INSPECTION REPORT: GREENS CREEK MINE

Tongass National Forest Minerals Group 8510 Mendenhall Loop Rd Juneau, AK 99801 (907) 789-6276 – office (907) 586-8808 – fax Date of Inspection: Wednesday, May 24, 2017 Date of Report: Friday, June 9, 2017

USDA Forest Service Inspector: Edward Gazzetti

Inspection Report 383 Page **1** of **7**

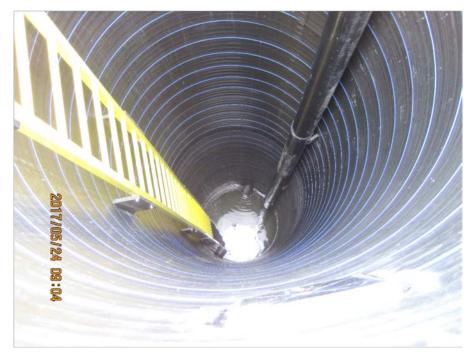
Unlike Pond 7's single-liner design, Pond 10 is lined with primary (upper) and secondary (lower) membranes, both made of 80mm HDPE. A drainage layer between the membranes has the ability to convey potential leakage to a small pipe housed in Wet Well 11 where a transducer monitors water levels and can notify HGCMC personnel if a leak exists (Photo 4). Perforated piping beneath the secondary membrane drains groundwater to Wet Well 11 to relieve pressure caused by upwelling.
